**City of Portland, Maine – Building or Use Permit Application** 389 Congress Street, 04101, Tel: (207) 874-8703, FAX: 874-8716

**Minor/Minor Site Review for New Detached Single Family Dwelling,  
All Purpose Building Permit Application**

BUILDING PERMIT REPORT

REASON FOR PERMIT: Interior renovations

Second Floor

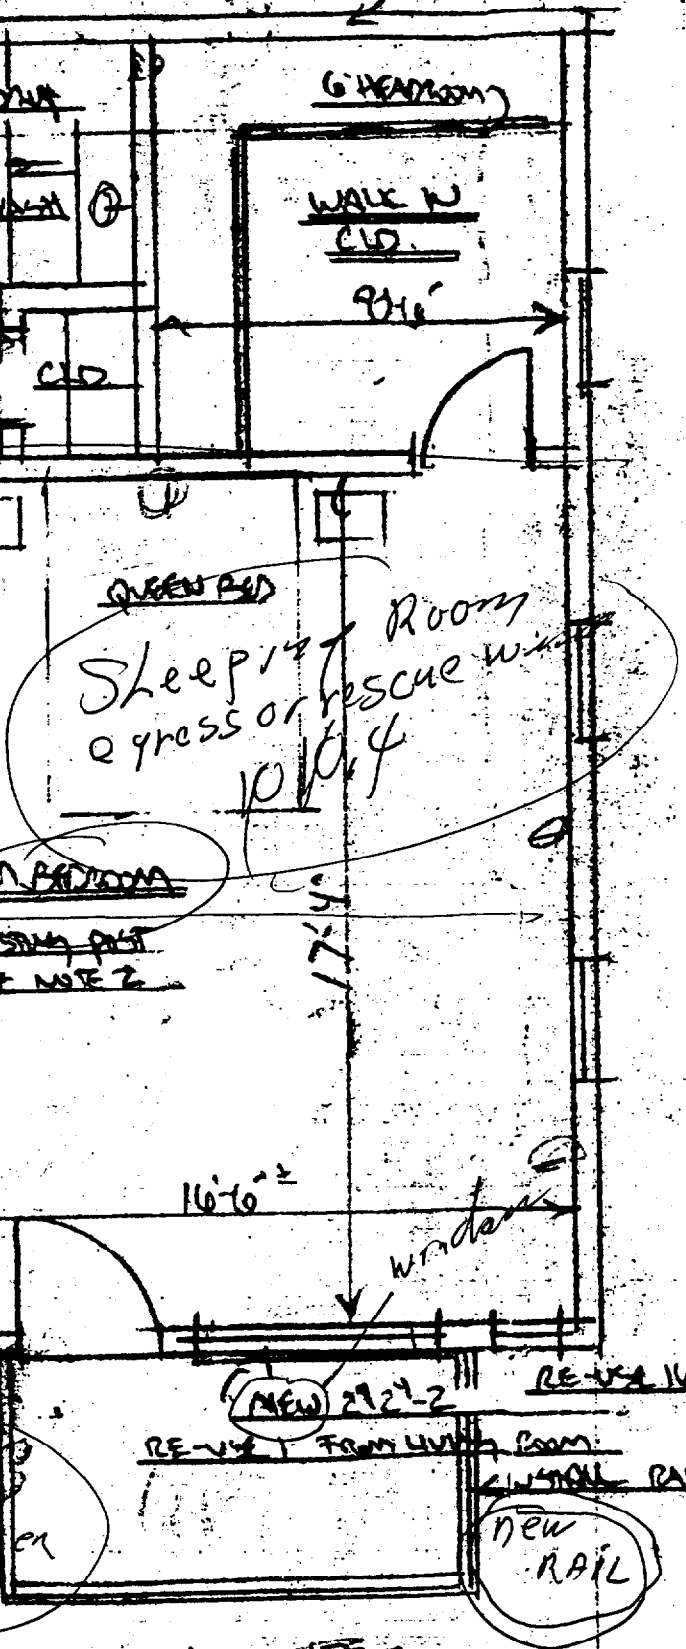
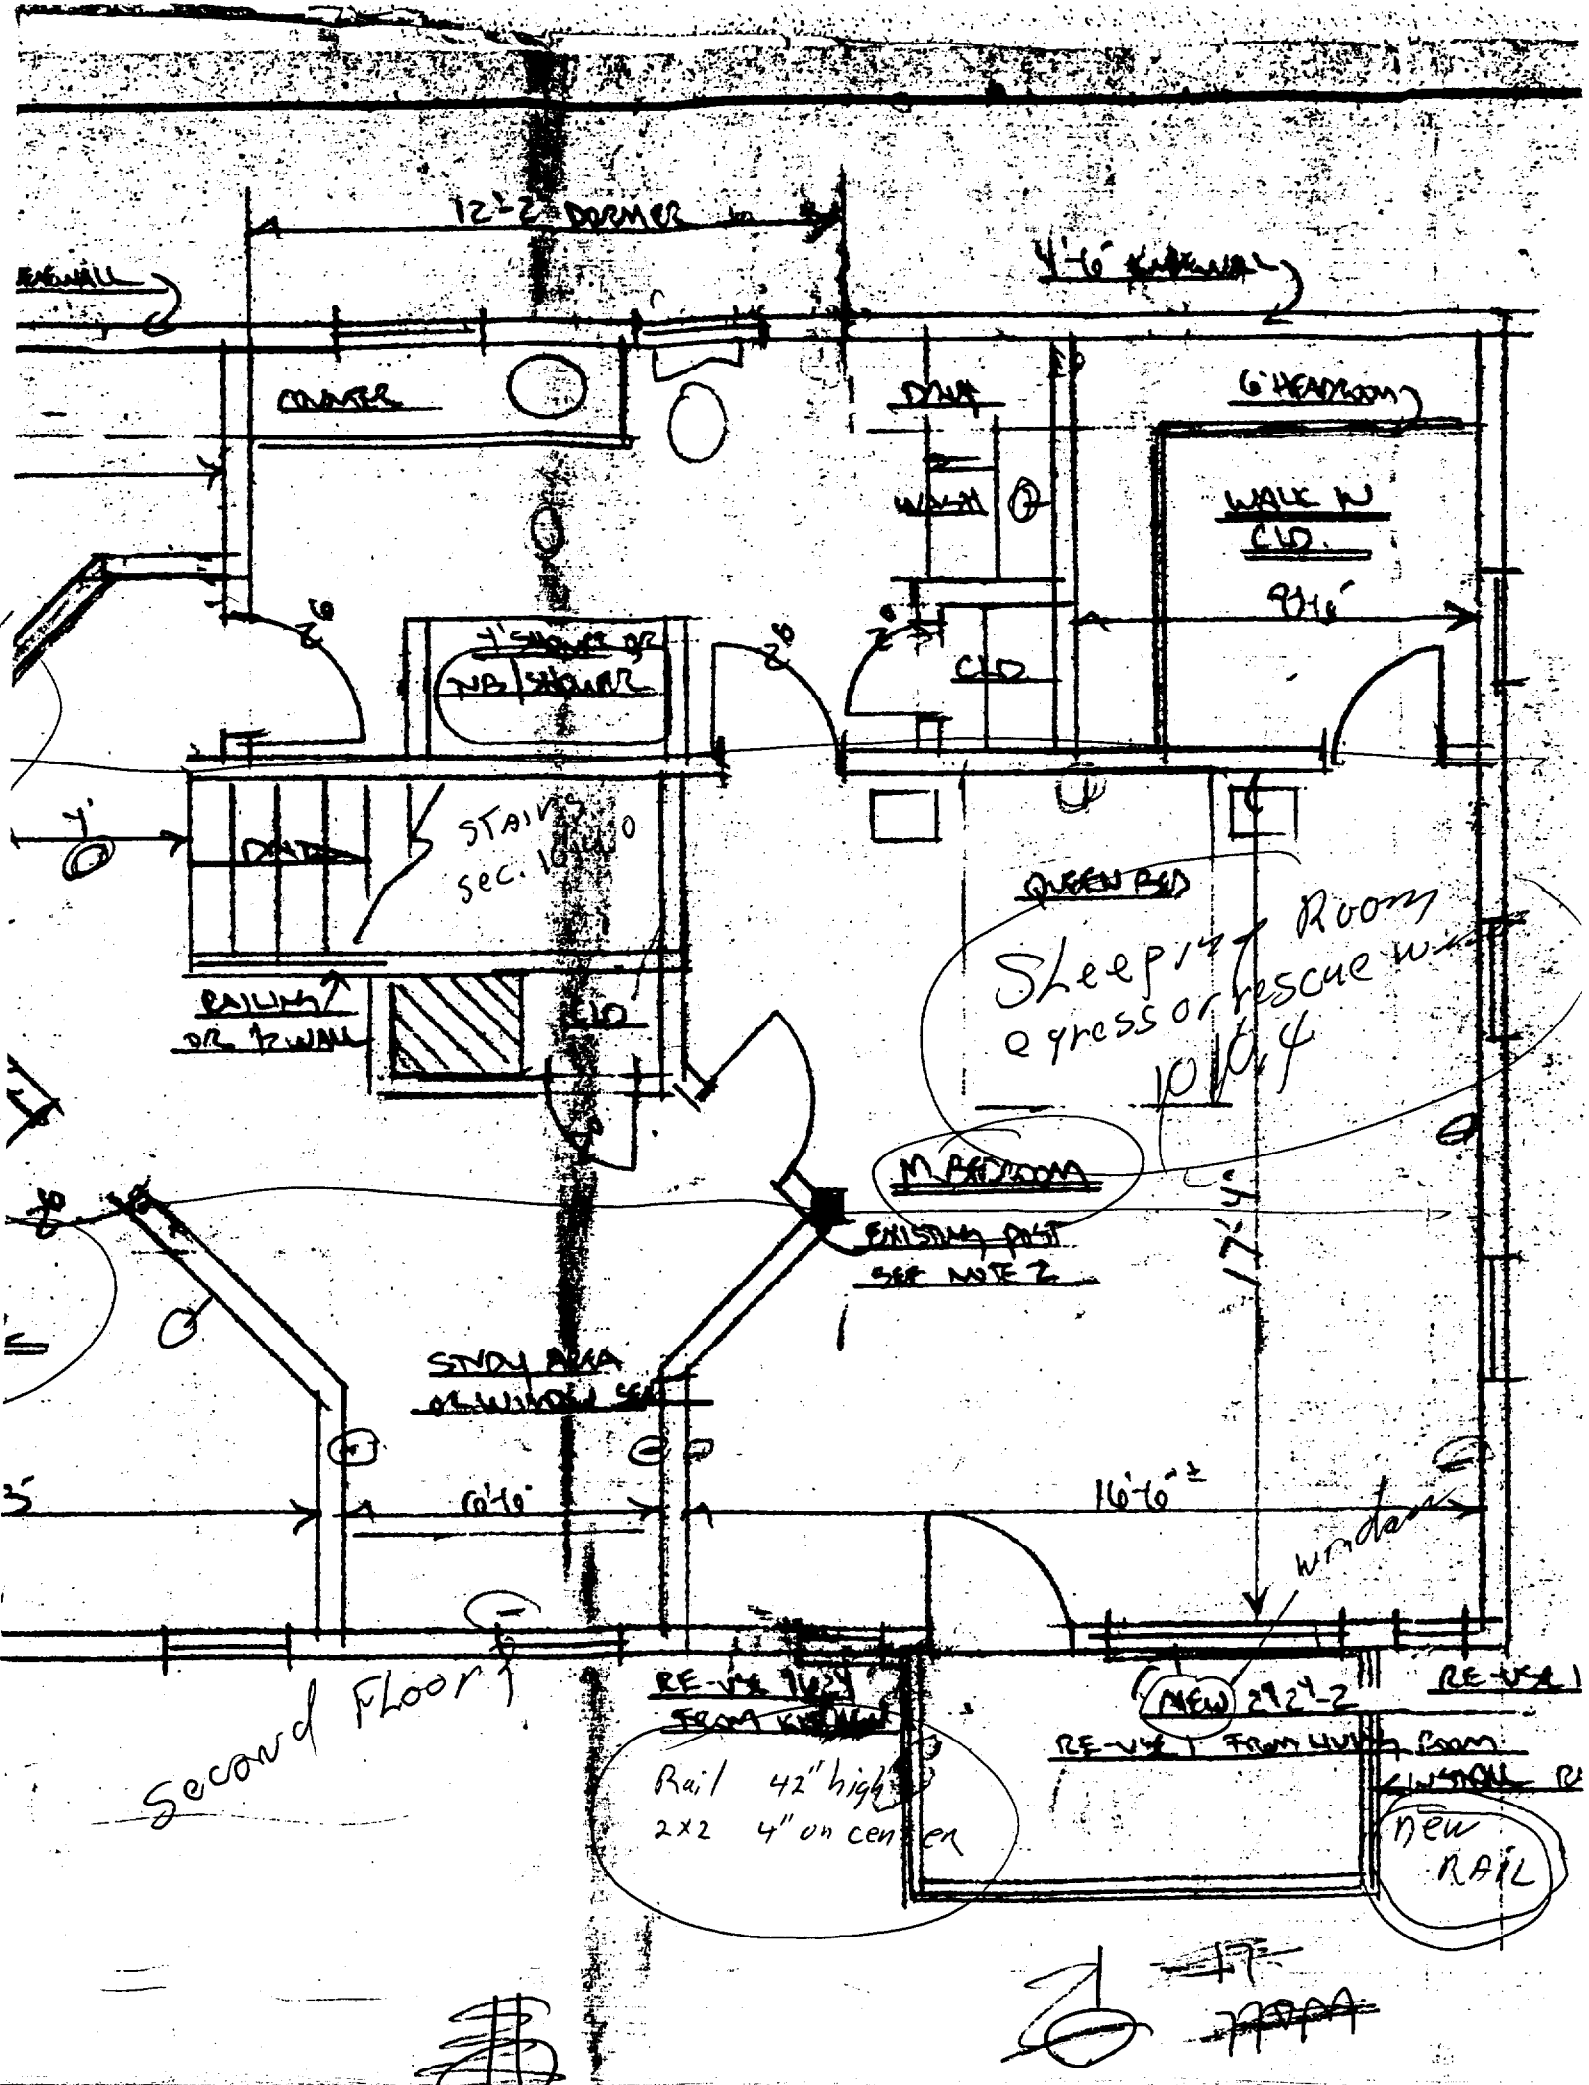
X37. Your plans did not have a Floor Framing detail (existing) - The bldg code requires a design live load of 30 Psf for sleeping areas - Before any work is started, a complete framing detail shall be submitted and approved.
